Staff Report to the Western Weber Planning Commission

Application Request: Consideration and action on a request for preliminary approval of Henry Flats Cluster Subdivision consisting of 12 lots, located at 4300 West 400 South

File Number: LVH051914

- A. Proposed subdivision plat
- B. Location Map

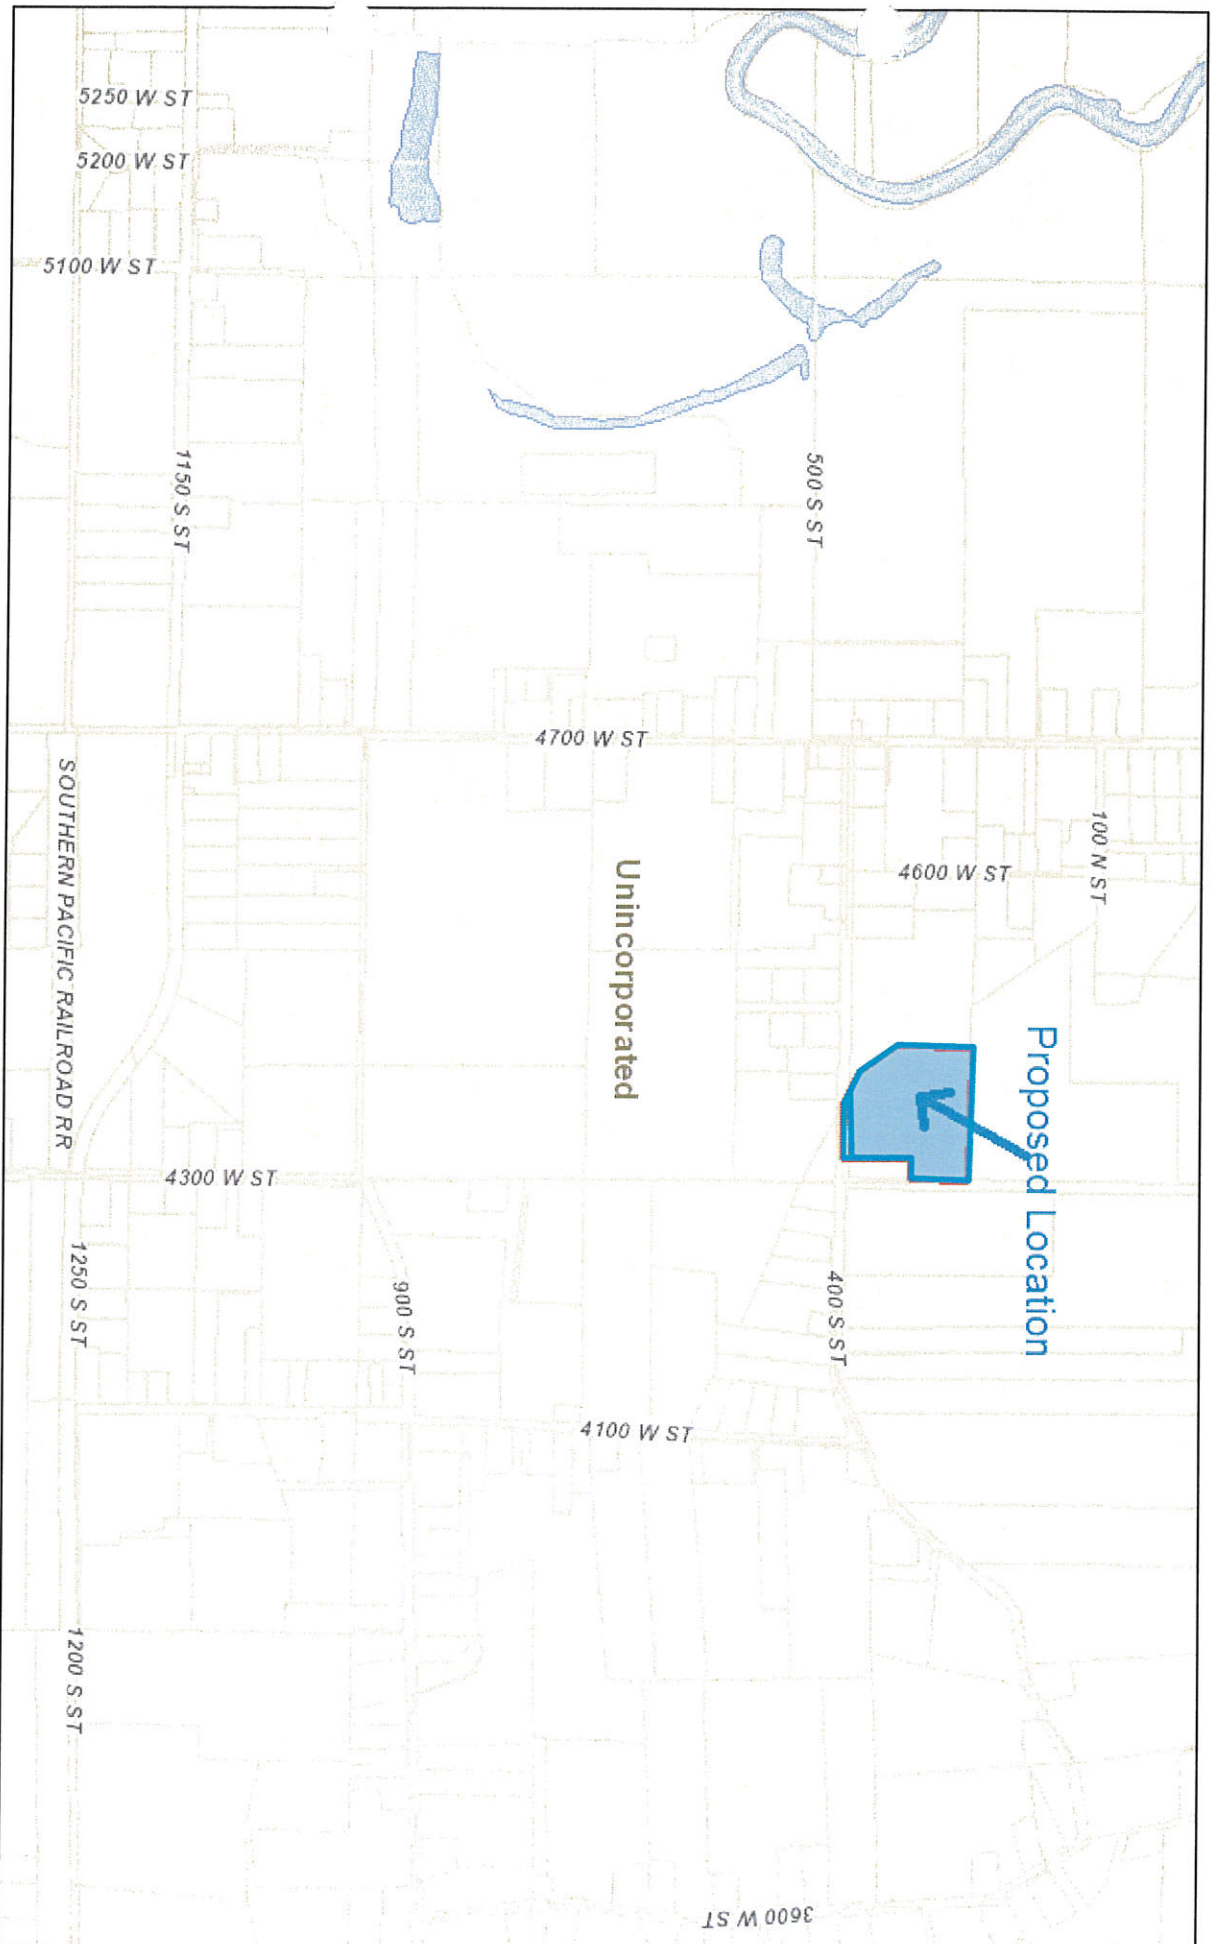
Culinary water will be provided by Taylor West Weber with the developer creating a pond for irrigation water. A water capacity assessment letter needs to be provided prior to final approval. The applicant has Hooper Irrigation water shares. There is still a question as to where the secondary water pond will be located. This information should be presented to the Planning Commission.

The County Engineering Division wants the ditch in the front of the property to be piped. If the curb, gutter, and sidewalk are deferred, then the grade will need to be brought up to within a foot or less below the edge of asphalt. A note will need to be added to the plat stating: "Due to the topography and the location of this subdivision all owners will accept responsibility for any storm water runoff from the road adjacent to this property until curb and gutter is installed. A Storm Water Pollution Prevention Plan (SWPPP) is required to be submitted for all new development where construction is required. A Storm Water Construction Activity Permit is required for any construction that:

Wastewater treatment will be provided by individual septic systems. The original subdivision plat that was submitted had 13 lots. After a year of water monitoring and working with the Health Department, the Health Department has approved the subdivision for 12 lots with the condition that lots 7-12 are approved for a 3 bedroom home. A note on the plat and a covenant that is recorded as part of this subdivision needs to indicate this requirement. The reason for the limitation is because of the irrigation ditch on the rear of the lots.

The applicant is asking for a deferral of curb, gutter, and sidewalk. However, since the lots are below 40,000 square feet, should curb, gutter, and sidewalk be required? The review from the Weber School District states "elementary students are not eligible for bussing to West Weber Elementary site".

Staff recommends preliminary approval of Henry Flats Subdivision with 12 lots, subject to staff and agency requirements, with the requirement for curb, gutter, and sidewalk, as this subdivision is within walking distance to West Weber Elementary School, the lots are smaller than an acre in size, and the students are not eligible for bussing.
